Oxley Highway to Kundabung

Urban Design and Landscape Plan Addendum

This addendum has been prepared to update a number of sections of the UDLP, specifically in relation to the rehabilitation of the main site compound at Ch. 7000.

Figure 1 Update to Figure F6.2.7 from the UDLP

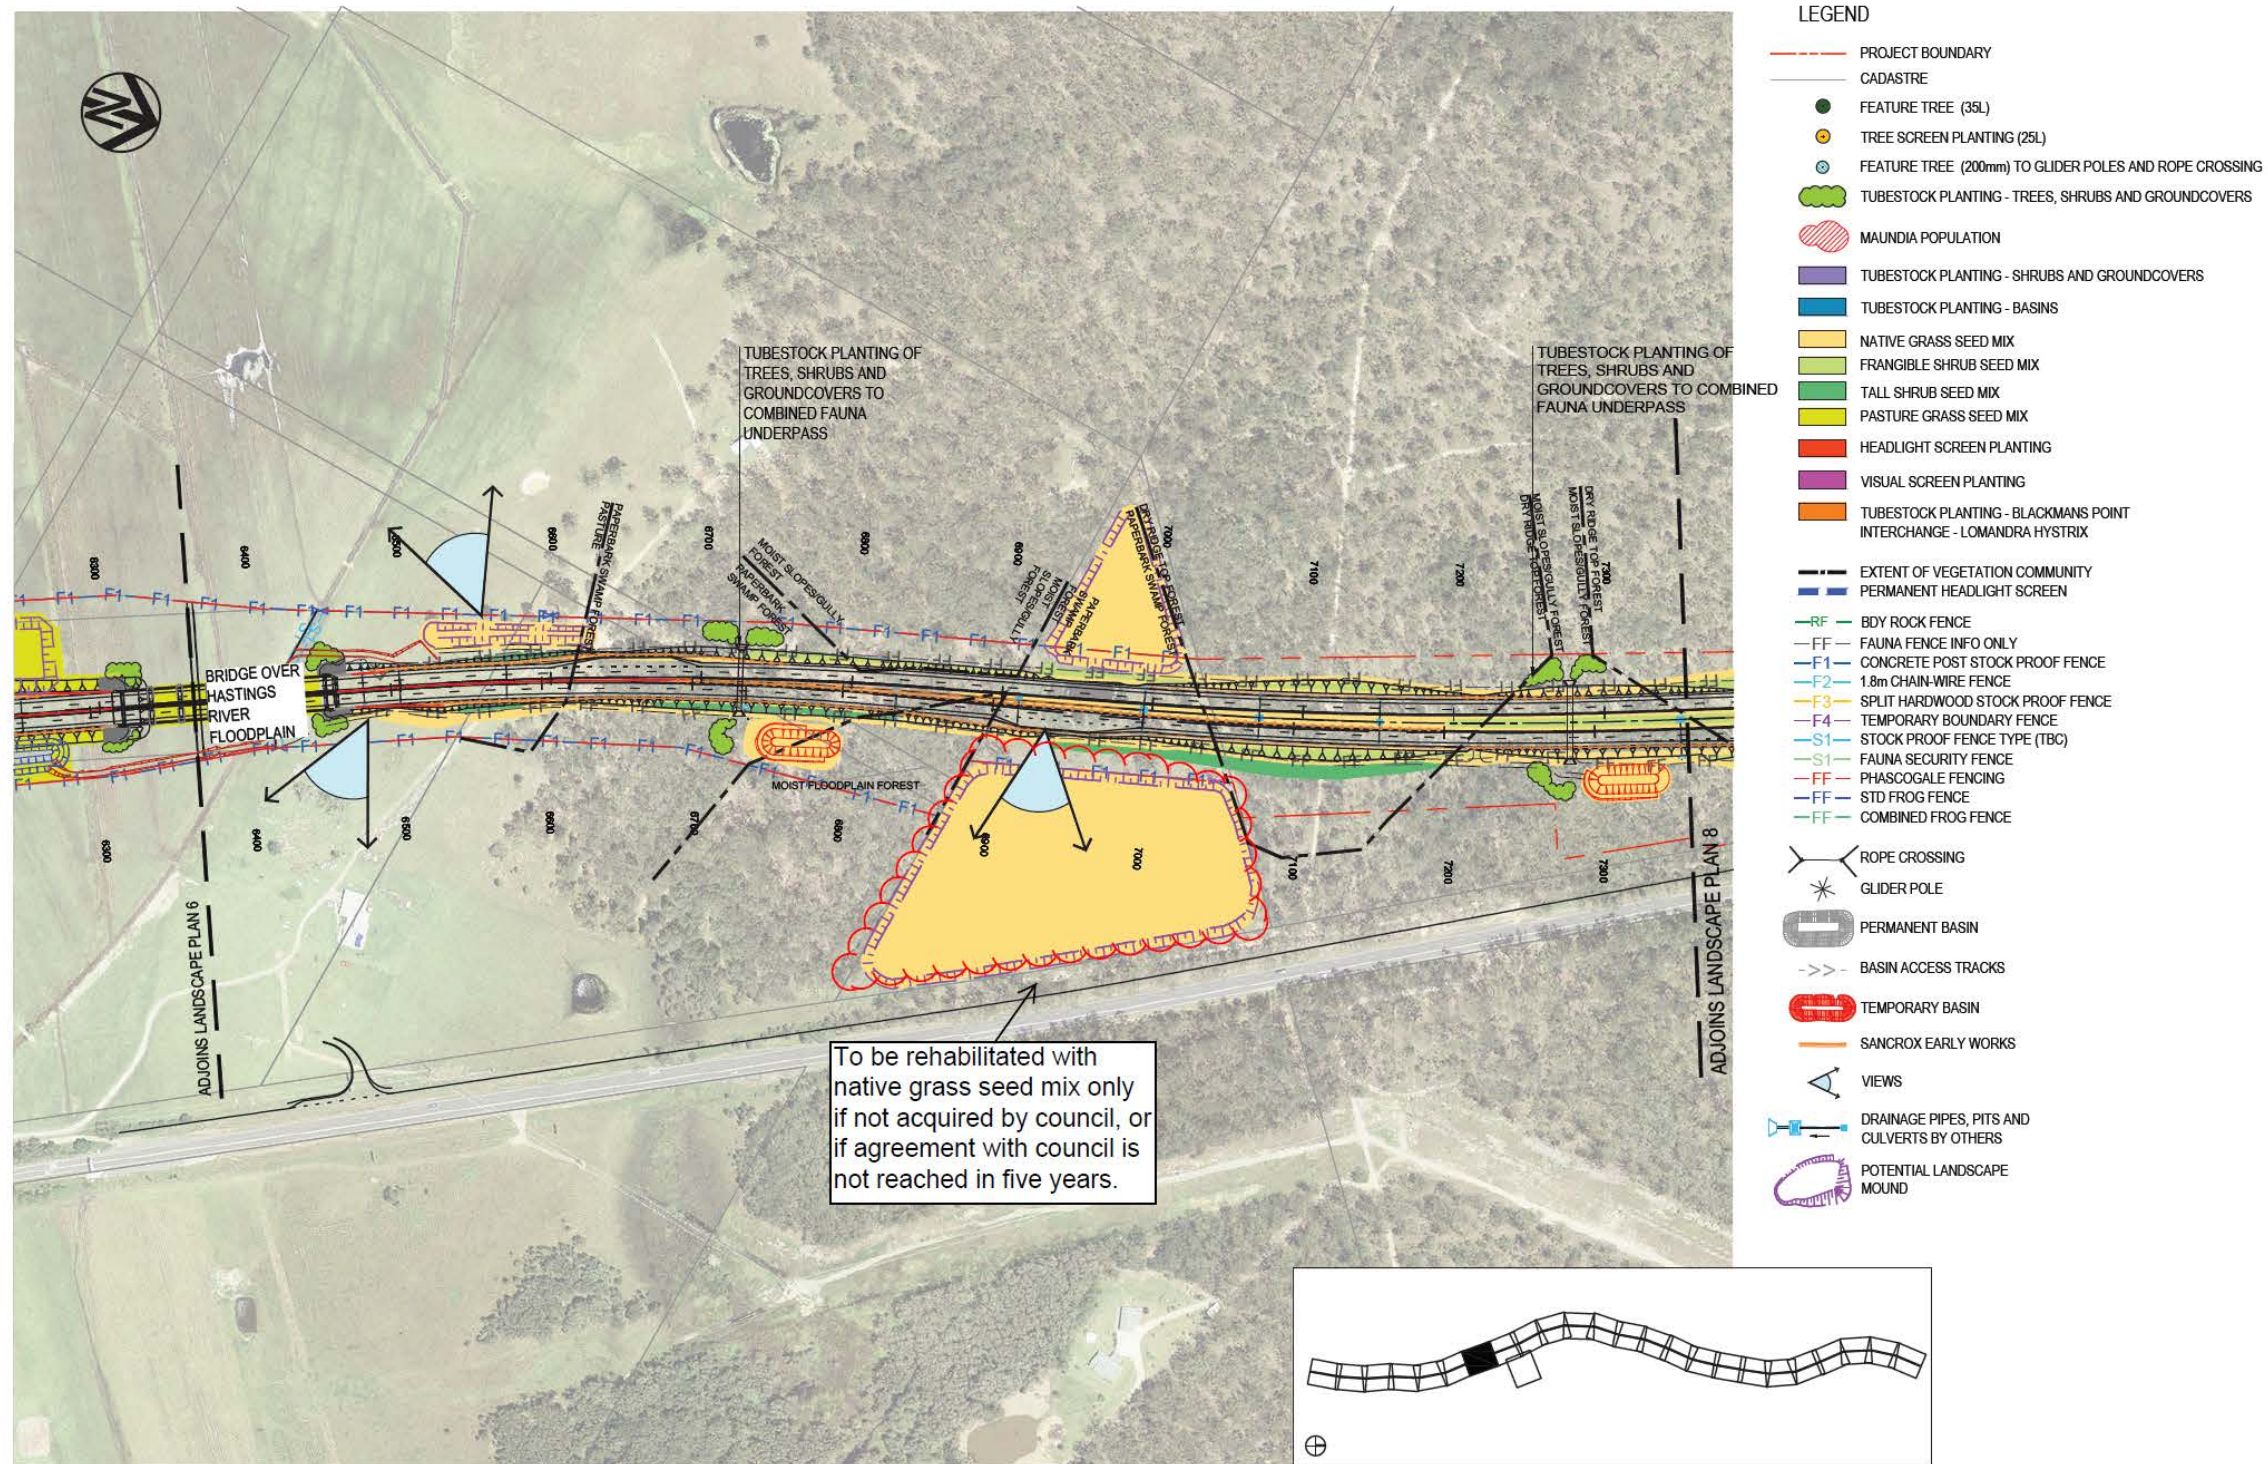
Section	Plan currently states / shows	Updates
Figure F6.2.7	Shows: the main compound area being rehabilitated with native grass seed mix & shows 'views' to the east	See updates in Figure 1 below.
F.8	States: 'As a minimum, these sites [temporary ancillary facilities, access roads and watercourses that cross the project alignment] will be prepared as for other vegetated areas, topsoiled and seeded with native plants, native grasses or pasture grasses in order to restore the site to its former condition.'	[additional sentence] The eastern side of the main compound site at Ch. 7000 will be rehabilitated only if the site is not acquired by Port Macquarie Hastings Council, or if agreement has not been reached for acquisition within five years.
F.8.1	States: 'Where ancillary facilities are located within Roads and Maritime owned land, the site is to be rehabilitated as required by the Roads and Maritime specification R178 Vegetation when no longer in use.'	[additional sentence] The main compound at Ch. 7000 is owned by Roads and Maritime. This will be rehabilitated only if the site is not acquired by Port Macquarie Hastings Council, or if agreement has not been reached for acquisition within five years.
